Subject: Requesting Class II permissive change for FCC ID: 2AXJ4X50

The purpose of this letter is to request a Class II Permissive change for FCC ID: 2AXJ4X50, original granted on 11/01/2021.

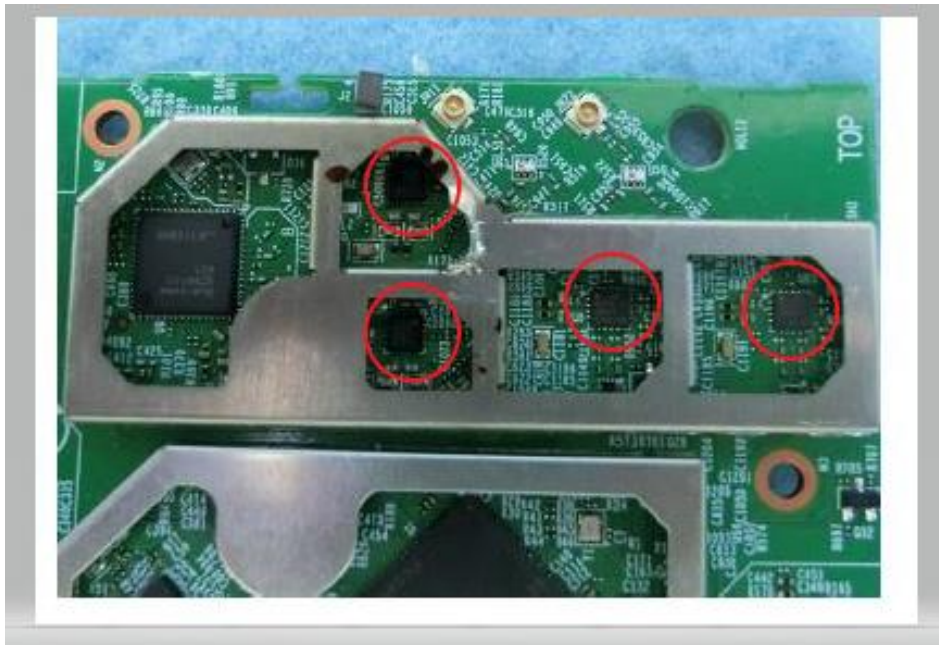
- a. Removed the components of the terminals U36 and U37.
- b. Pin-to-pin changes in the FEM chip.

The FEM model change “2.4G SKY85337-11 5G: SKY85755-11 ” to
“ 2.4G VC5337-31 (U8、U65) ; 5G: VC5788-21” (U61、U62)

c. Changes in the wiring at the power supply of the PCB.
